Dekko Apparels Ltd. (10450)
Shamrin Tex Ltd (9187)
Agami Apparels Ltd

Plot #62, Kathgora, Amtola, Ashulia, Savar, Dhaka, Bangladesh

13.APRIL.2014

Identified Priority 1 Concerns

On ceiling of 4th floor

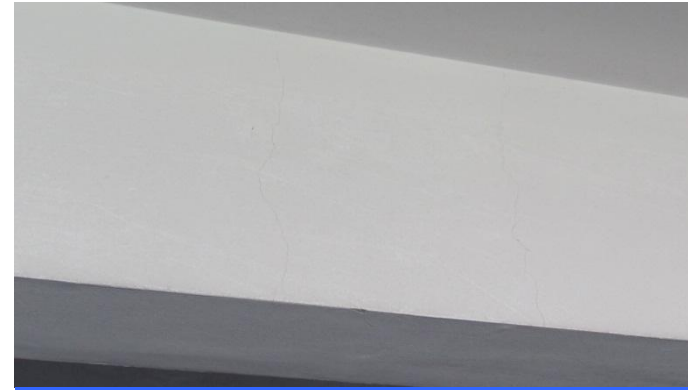
Waterproofing is not provided at the current roof level. In some locations the brick aggregate can be seen on the surface of the roof (5th floor). This poor construction has led to the water ingress seen on some of the lower levels. Water penetration will allow corrosion of the reinforcement and could possibly lead to future structural failure.

Water ingress on the stair wall

On the ceiling of the 4th floor level

Water ingress

- Provide a proper waterproof layer on the existing roof level.
- Actions any recommendations resulting from the DEA.

It is intended to construct new levels above 5th floor level

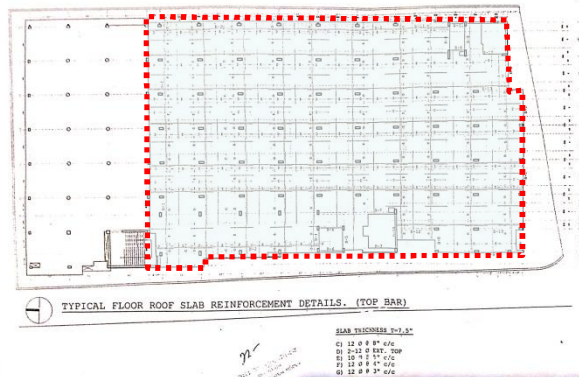
At the time of site investigation we were not provided with the full set of structural drawings. We were allowed to remove some concrete of a column at the ground floor level to determine re-bar diameter for. The columns surveyed are adequate with a reasonable loading assumption for the levels already built. However, adding one or more floors on the existing structure needs to be investigated as part of a Detailed Engineering Assessment before commenced.

With our preliminary calculation, the building will be rated as AMBER if 3 concrete stories would be built on top of the existing 5 story building as per drawing permit

- Carry out a Detailed Engineering Assessment to ensure that the existing structure is capable of supporting all planned extra levels.

- Cease construction at whatever level the Assessment determines the existing structure is capable of supporting.

Slab design of
typical floor (top
bars)

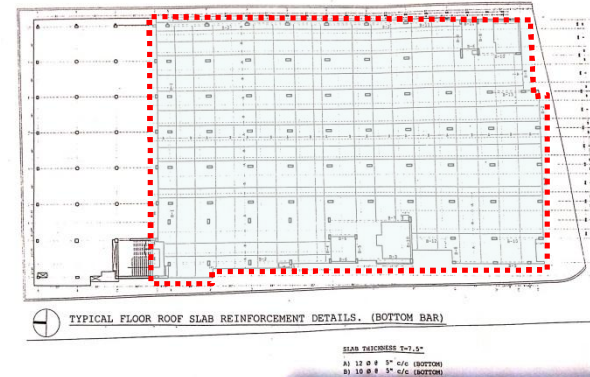
Part of building has been
designed with flat slabs. All other
structural drawings are missing

The South side of building has flat slabs and concrete columns. No lateral stability system is evident. It is unclear what resists lateral loads.

A lack of lateral support system able to resist wind or earthquake loads. This should be investigated fully as part of a Detailed Engineering Assessment.

The set of structural drawings provided for the South side of the factory only covered the slab detailing. All other designs are missing.

- Assess the building's lateral stability capacity as part of the DEA.

- Provide any new forms of lateral structure that may be required as a result of the DEA.
